# City of New Bedford

## STAFF COMMENTS

#### CASE #25-15

Request to consider a Site Plan Review for a proposed 92,000 +/- SF warehouse/freezer building with associated parking and rail spur located at N S Samuel Barnet Boulevard (Map 133, Lot 63) in the Industrial C zoning district.

**Site Plan Review:**  
(Attachment 3).

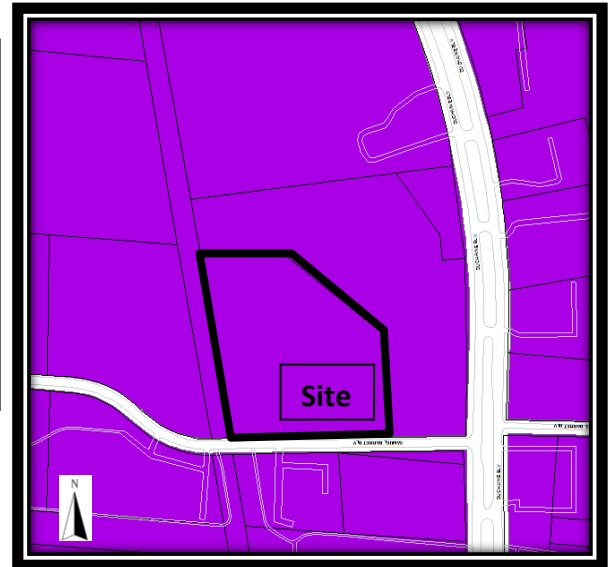
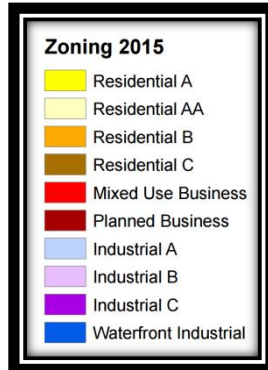
**Parking** The revised Site Layout plan illustrates thirty six (36) spaces for parking and eight (8) bays for loading satisfying the required thirty-six (36) parking spaces for this proposed development, sixteen (16) per GFA stipulations and ten (10) for each vehicle used in business. In addition to these parking spaces the applicant proposes 8 loading bays where six (6) bays are required by ordinance. Loading bays are not counted as parking spaces.] Parking requirements will increase should the applicant choose to expand the facility in the future as they anticipate.

**Landscaping** –The submitted Landscaping Plan is not a complete landscape plan, but features a notation that landscaping for the site is shown for “permitting purposes” and the contractor is to “coordinate final species with owner and city prior to construction.” The Planning Board typically formalizes such Landscape Plans at the public hearing. Any nonresidential area used for loading or storage of new material or products is subject to Subsection 3324 of Section 3300, Screening and Landscaping. No information regarding snow removal/storage has been indicated within the application or plan sheets, particularly relevant given both the lack of clarity around proposed plantings and the sensitive nature of the surrounding wetlands system.

**Elevations** – Elevation Drawings are labeled as the observer is facing the building façade, rather than oriented to the North Arrow Site Layout plan (Attachment 4). The applicant will present Elevation corrections at the Planning Board meeting.

- The Landscape Plan shall be updated to include a plant schedule, greater detail as to what is to be retained and what is to be added in addition to the snow storage area to the satisfaction of planning staff.

- Building Elevation plans to be clarified and agree with the Site Layout building location.
- Building Elevation plans to identify all proposed exterior materials -including roofing and treatment at the loading docks, rail spur access point and all building entrances.
